## Design Review Subcommittee (DRSC)

Meeting Date: November 11, 2015

**SUBJECT:** **Minor Cultural Heritage Permit 15-055, Cyr Remodel**, a request to add a new covered balcony to the front of an existing triplex located at 253 Avenida Del Mar. The project zoned Mixed-Use and is in the Architectural, Pedestrian, Central Business District, and Coastal Zone Overlays (MU3-A-P-CB-CZ).

**Exhibit 1- Original Rendering**

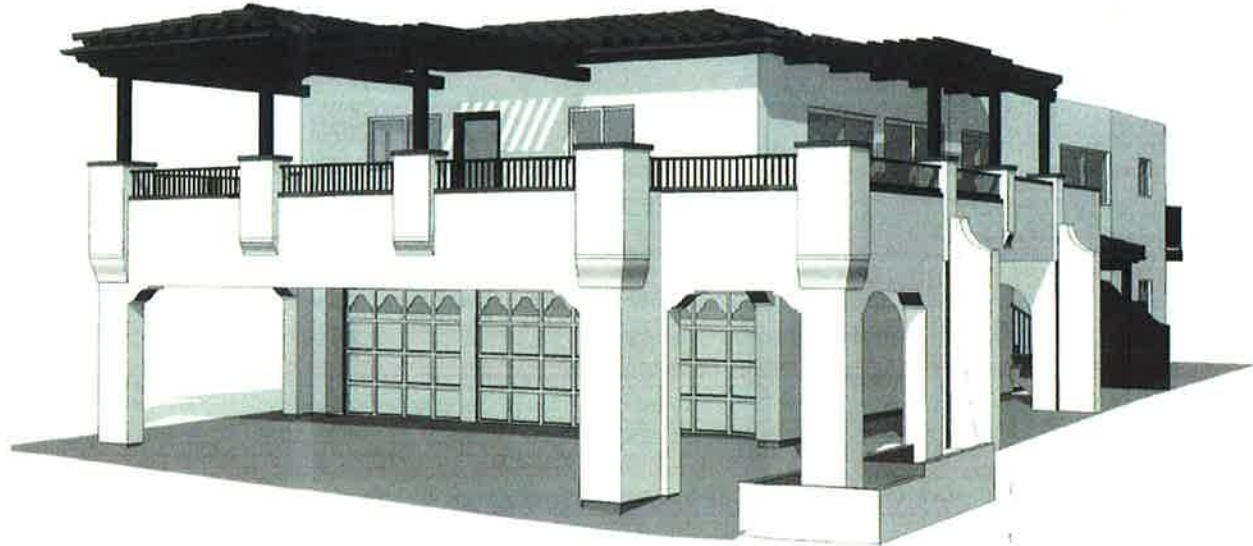
<b>Detail</b>	<b>DRSC Comment</b>	<b>Proposed Modification</b>
Front- Deck Columns	Simplify the columns and eliminate massing.	<b>Modified as requested.</b> Columns were simplified and look less heavy.
Front- Supporting Columns	Columns are proposed as half columns and need to be full squares to be proportionally accurate and traditional.	<b>Not modified.</b> Renderings and plans still show half columns. Please modify to full square columns.
Front- Garage Doors	Modify the garage doors.	<b>Modified as requested.</b> The applicant has painted the garage doors dark brown to match the trim.
Front - Trellis	Recommended using a minimum of 6x posts.	<b>Modified as requested.</b> Posts are 6x with corbelled ends and 4x trellis members.
South Elevation- Guardrail	Proposing a mix of glass and wrought iron railing, DRSC recommended all wrought iron.	<b>Modified as requested.</b> All glass was removed and changed to wrought iron.

North Elevation- Cornice	Applicant proposed to paint the cornice dark brown, it was recommended it remain white.	<b>Not Modified.</b> Plans still show cornice as being dark brown.
North Elevation- Wing Walls	Not proposed as a traditional detail it was recommended they be removed.	<b>Modified as requested.</b> Wing walls have been eliminated from plans.
Building Stucco	Applicant originally proposed smooth stucco on a portion of the building.	<b>Modified.</b> Applicant has chosen to re-stucco the entire building to a smooth white finish.
Lighting	Decorative lighting should be shown on eh plans.	<b>Modified as requested.</b> Light fixtures have been added to the front elevation. The fixture shall be reviewed and approved by staff with a condition that they be dark skis friendly.
Windows and Doors	Building currently has white vinyl windows, recommendation was for wood or fiberglass windows and doors on the front elevation.	<b>Modified.</b> The applicant has stated that the vinyl windows are the type that can be painted and is proposing to paint all window and door surrounds dark brown to match the trim. Staff recommends that the front windows be modified to wood or fiberglass per City policy and is supportive of painting the windows
